Transmission for Broadcast Management Message (15.3.6.5.2)

IEEE C802.16m-09/2451

Comments on IEEE P802.16m/D2 for IEEE 802.16 Working Group Letter Ballot Recirc #30a

Area: "15.3.6 Downlink control structure".

Proposed Structure

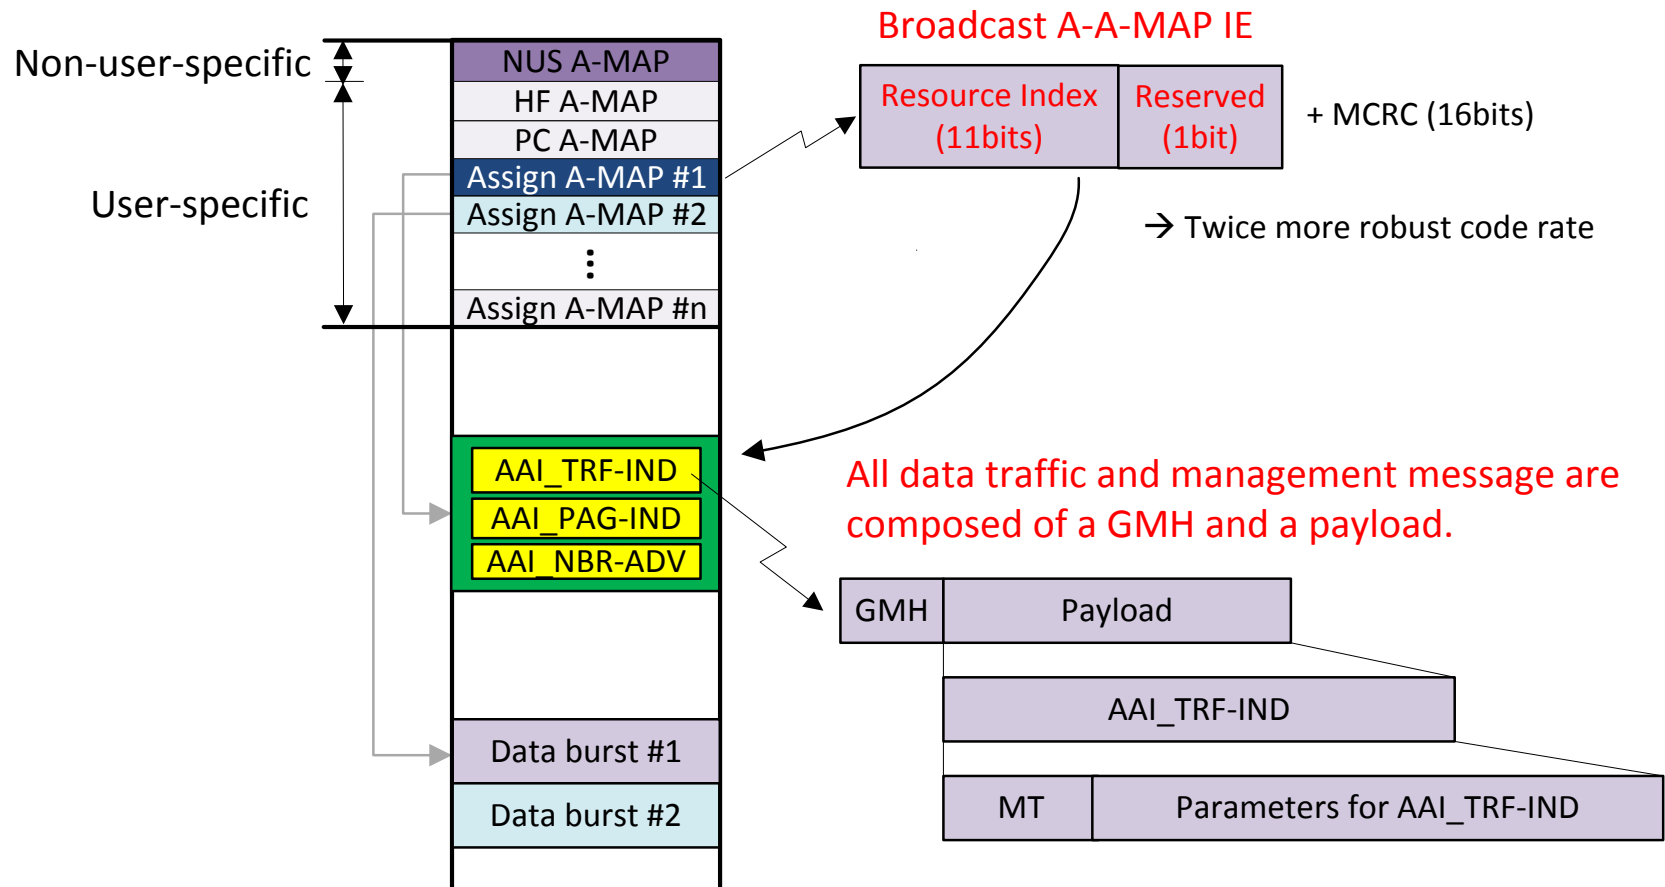
▪ (Proposal) Assignment A-MAP

- In primary frequency partition, only one Broadcast A-A-MAP IE is present at the beginning of either group 1 or group 3 in A-A-MAPs, if exist.
- No flag bit in NUS A-MAP
- Twice more robust code rate: 1/8 or 1/16 at group 1 and 1/4 at group 3

- **(Proposal) Broadcast burst transmission**

- One broadcast burst includes one or multiple broadcast management messages
- AMS delineates the boundary of each MAC PDU (management message) in the broadcast burst by decoding its GMH
- AMS identifies the type of broadcast management message by referring to message type (MT) in each MAC PDU

In primary frequency partition, a Broadcast assignment A-MAP IE is present at the beginning of either group 1 or group 3 in assignment A-MAPs, if exist.

■ Method

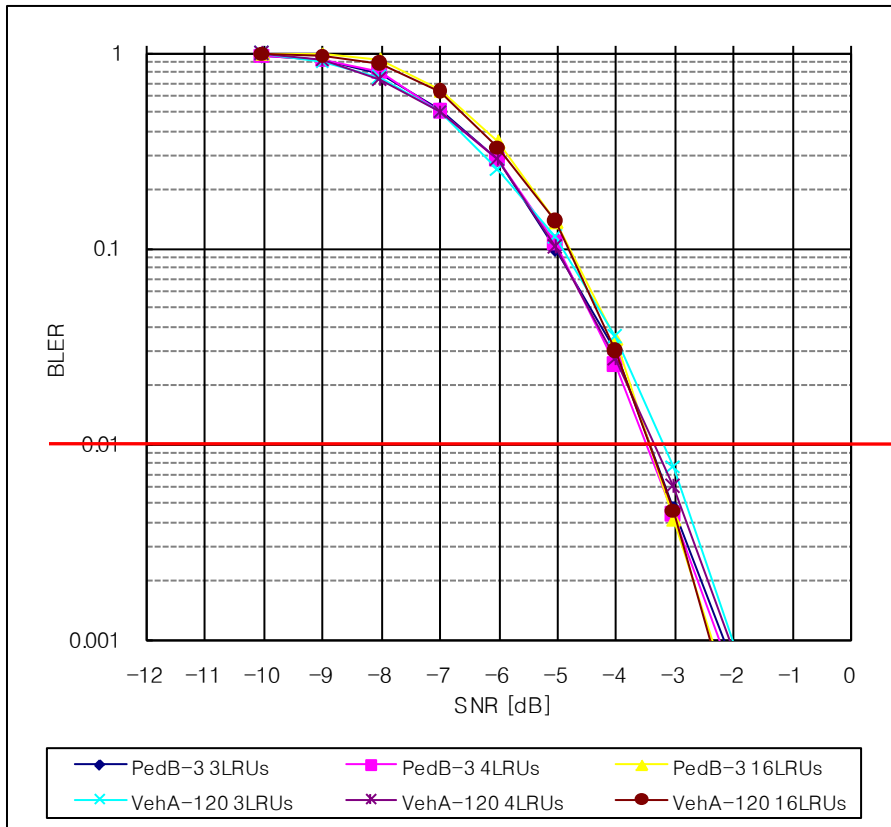
- LLS curves: Find SNR value (x) at 1% FER
- Geometry distribution: Find SNR value (y) at 5% CDF
- If $x > y$: outage requirement is NOT satisfied.
- Else ($x \leq y$): outage requirement is satisfied.

- $x = -3.5$
- $Y = -3.7$ (EMD baseline), -5.6 (Open rural macro)
- In EMD baseline and Open rural macro, the current lowest code rate CANNOT meet the requirement

→ **(Proposal) twice more robust code rate**

Result-2: Geometry Distribution

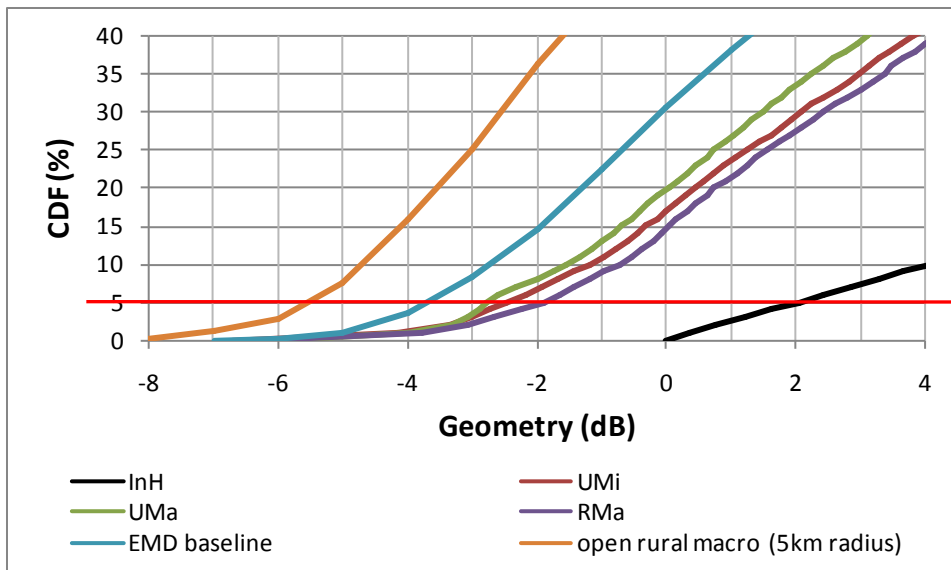
- In Geometry distribution, Find SNR value at 5% CDF

Test Scenario	SNR@5% (dB)
InH	2
UMi	-2.5
UMa	-2.8
RMa	-1.9
EMD baseline	-3.7
Open rural macro (5km-radius)	-5.6
